Product Change Notice (PCN)

PCN Number: PCN-65690916R-01

Product(s) Affected: V78-500-SMT series and V78-1000-SMT series (including SMT-TR configurations).

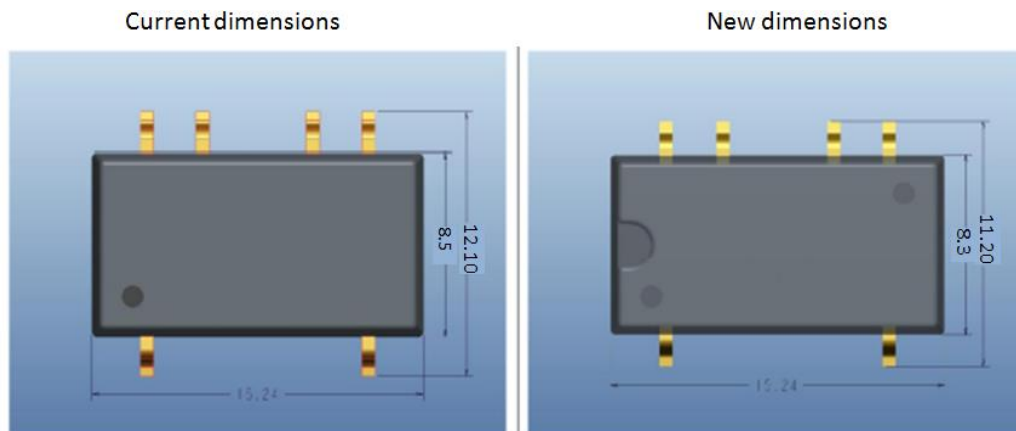
Description of Change: The V78-500-SMT and V78-1000-SMT series have been updated with minor changes in packaging to accommodate manufacturing process improvements.

The primary changes are to package width from 8.50mm to 8.30mm (including pins changed from 12.10mm to 11.20mm).

The new design will be distinguished with a semi-circle for the pin-orientation marking.

Additional Information: Existing PCB layouts should not be affected by the change. Testing has shown backward compatibility to the current recommended PCB layout.
